RFP FOR MOVEMENT OF 3MMT OF IMPORTED COAL PER ANNUM FOR A PERIOD OF 10 YEARS THROUGH INLAND WATERWAYS TO NTPC POWER PROJECT LOCATED AT BARH, BIHAR

CORRIGENDUM TO THE REQUEST FOR PROPOSAL DOCUMENT

The following corrigendum's are hereby incorporated as part of Request for Proposal , (the "RFP"), issued in relation to Movement of 3 MMPTA of Imported Coal for a Period of 10 Years through Inland Waterway to Barh STPP and the RFP shall stand modified and amended accordingly.

III. Navigation Lock System

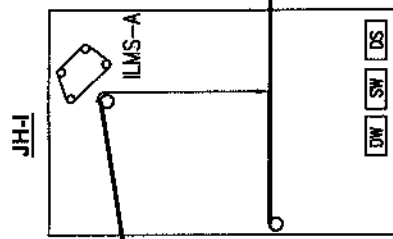
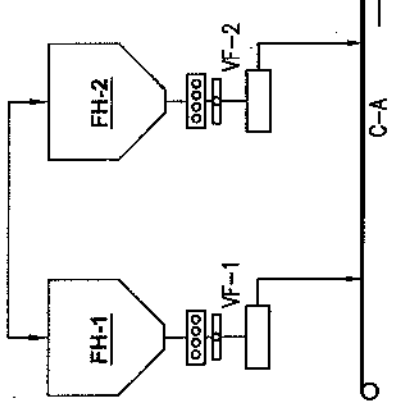
17.	Draft Tripartite Agreement (Volume II RFP)	Schedule E, Page 77	The entire Schedule E: Details of Navigational Aids is revised and attached hereunder.

The navigation lock system at Farakka is mainly for movement of vessels between the river Ganges and the canal connecting river Bhagirathi. Main dimension of the lock is provided hereunder:

- (1) Internal length 179.8 m,
- (2) Clear width between the two banks – 25.14 m with a internal depth varying from 18.09 m at u/s to 10.89 m at d/s.
